Comment on “Interferometric single-shot parity measurement in InAs–Al hybrid devices”, Microsoft Quantum, Nature 638, 651–655 (2025)

SUMMARY OF ISSUES IN NATURE 638, 651–655 (2025), MICROSOFT QUANTUM (REF. 1)

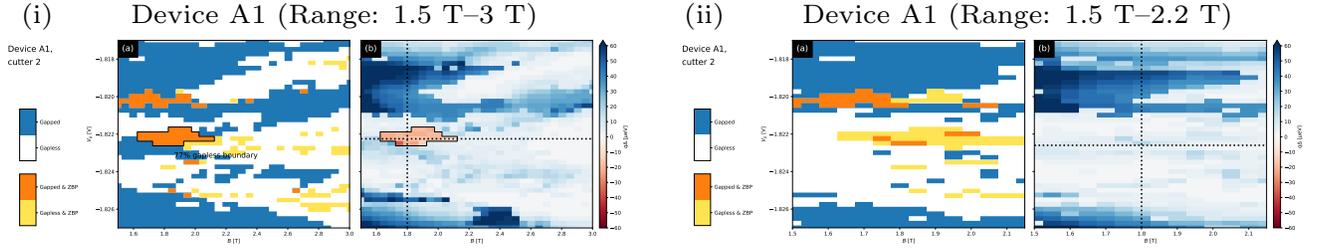
First, in Fig. 1 we show that the main region studied in Device A measurement 1 fails the TGP and is reported as gapless for a different choice of magnetic field range (1.5 T – 2.2 T)

than in Ref. 1 that still includes the region at $B = 1.8$ T where the purported parity readout occurs. This is the same TGP inconsistency as was reported in Ref. 2, but now also shown for the system studied in Ref. 1.

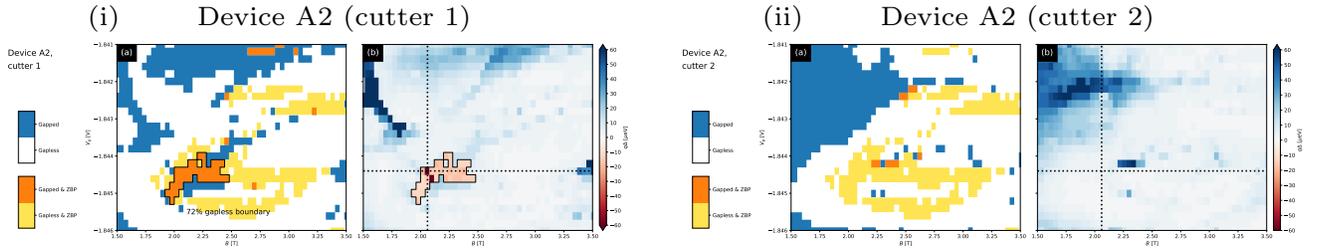
As was also reported in Ref. 2, the chosen cutter pair (junction transparency) can also change whether the TGP sees the identified region of phase space as gapped or gapless. In Fig. 2 we show that the main region studied in Device A measurement 2 ($B = 2.06$ T) is reported as gapless for cutter number 2. The reason why the TGP reports these regions as either gapped or gapless is because there is still sufficient nonlocal conductance at low-bias that changing the magnetic field range and/or cutter can alter whether the nonlocal conductance surpasses the threshold of 5% of the maximum that is required for the TGP to see the region as gapped [2, 8].

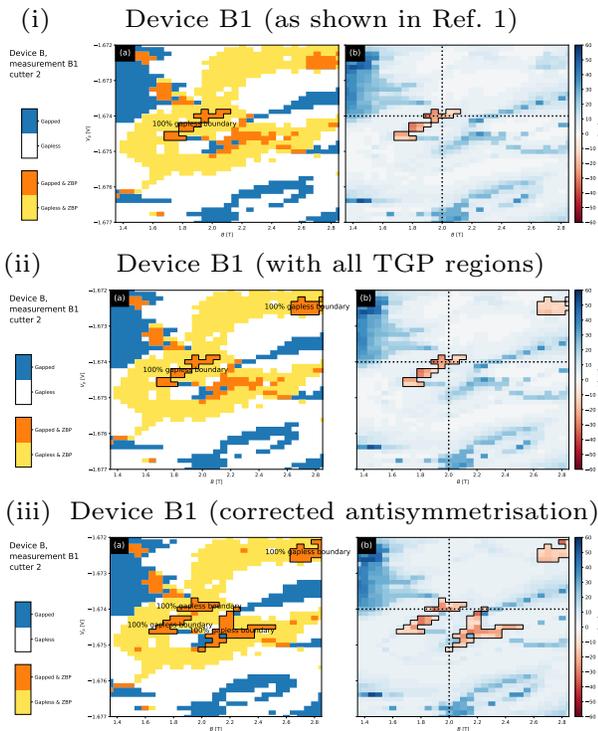
This statement is incorrect. As shown in Fig. 3(ii), applying the TGP as implemented in Ref. 1 but now with all regions identified by the TGP shown, Device B exhibits multiple regions that are identified by the TGP. In particular, in Fig. 3 there is a region ($V_p \approx -1.6725$ V, $B \approx 2.8$ T) that is identified by the TGP and where no ‘parity readout’ data was presented (a further third region in this device is present for other cutters and also passes the TGP). The only reason this region was not identified in the TGP phase cartoon shown in Ref. 1 was because the input to the TGP plotting code caused only the largest identified region to be highlighted.

Since this region of phase space was identified by the TGP, the purported parity readout should have been reproducible there, but this is not investigated in Ref. 1. As such, this incorrect reporting of the TGP outcomes strongly limited exploration of the expected reproducibility of the main effect reported in Ref. 1, despite reproducibility in other regions being a central question asked by several referees.

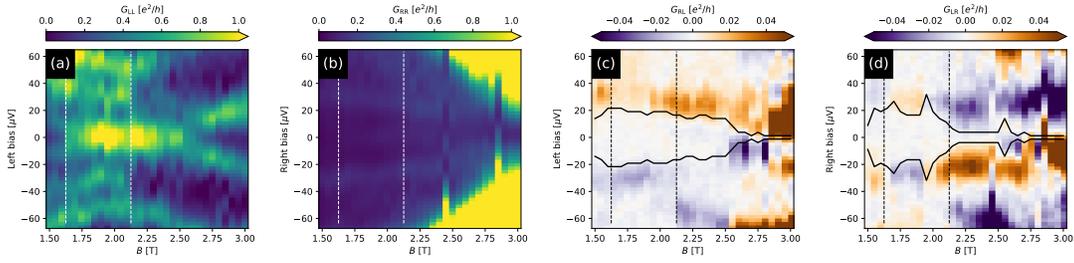
Starting with the local conductance in Figs. 4, 5, 6, it can be seen that there are a very large number of low energy states. Although the case for all devices, this is particularly striking for Device A2, cutter 2 [Fig. 2(f)], where there is strong finite

Similarly, the nonlocal conductance data in Figs. 4, 5, 6 reveal a large level of disorder and significant nonlocal conductance at low-bias consistent with a gapless system, as indicated by some of the TGP outcomes. For instance, in Device A2 both cutters shown in Fig. 2 have very large amounts of nonlocal conductance close to zero-bias.

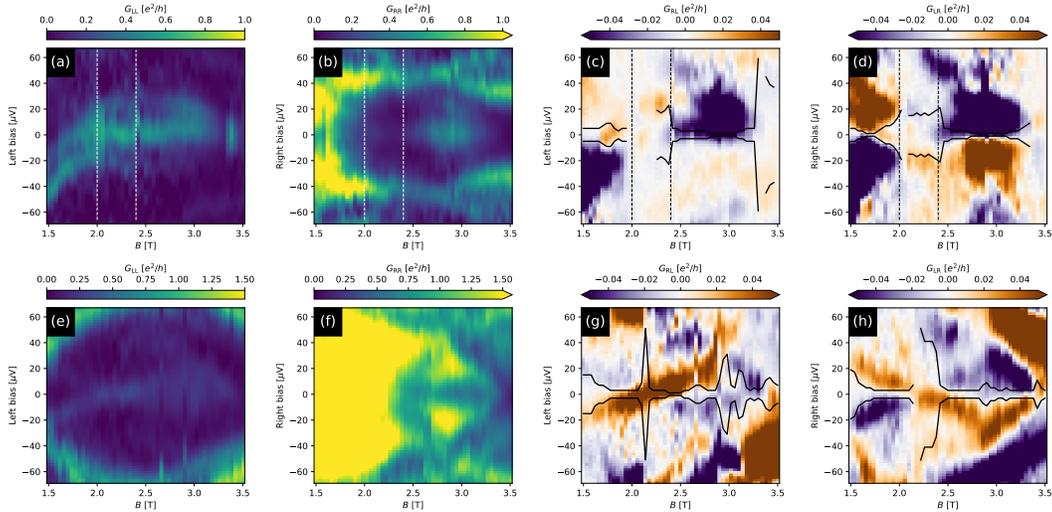
local conductance, G_{RR} , for almost the full range of bias voltages, indicating an abundance of low-energy states and there is also no clear SC gap features. It is also interesting to note that in all cases there is a sizable difference in magnitude of the local signal on each side of the nanowire.

this statement with both the local conductance and nonlocal conductance show broken particle-hole symmetry. In particular, considerable antisymmetric components of local conductance and symmetric components of nonlocal conductance are extremely clear, for instance, in Device A2 Fig. 5. Crucially, while the full nonlocal conductance can be substantial at low-bias and highly symmetric around zero-bias, the TGP is not sensitive to this due to the antisymmetrising of the conductance data, effectively cancelling out the symmetric component. Note that throughout we plot the full nonlocal conductance (not antisymmetrised) and, as a result, the solid black “gap” lines in the TGP plots (Figs. 4, 5, 6) do not reflect what the TGP inputs rather than the full nonlocal conductance.
